## **PROOF OF PUBLIC PARTICIPATION**

**Proposed subdivision and rezoning for mixed use development, Erf 878  
Riebeeck Kasteel**

**April 2026**

**Fig 7: Typical section through attenuation dam**

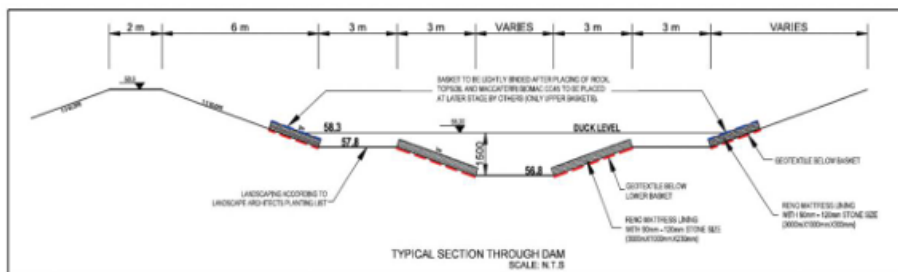
Two new stormwater attenuation facilities are proposed to be constructed as part of the development. The main purpose of these facilities will be to attenuate stormwater runoff and promote on-site infiltration. In order to achieve the required on-site attenuation, the storage volume of the attenuation facility must be able to retain a 1:50 post development flood event, while discharging a peak flow equal to only the 1:10 pre-development flow. These attenuation facilities will act as extended wet attenuation dams, which requires them to have a permanent pool with an extended attenuation storage volume above the permanent pool level. (Appendix G12: Civil Engineering Services Report, January 2025, p11/12). See Figure 7 from Appendix G7 below.

The engineering consultants need to show calculations of pre-development 1:10 runoff and the post-development 1:50 runoff with hourly timesteps and maximum flow volumes. There is also a need to calculate ingress of groundwater into the attenuation dams - from hydrogeological model. There is a need to properly size the dams and specify their precise location and your engineering consultants clearly have the expertise to do so – we would wish to see their calculations.
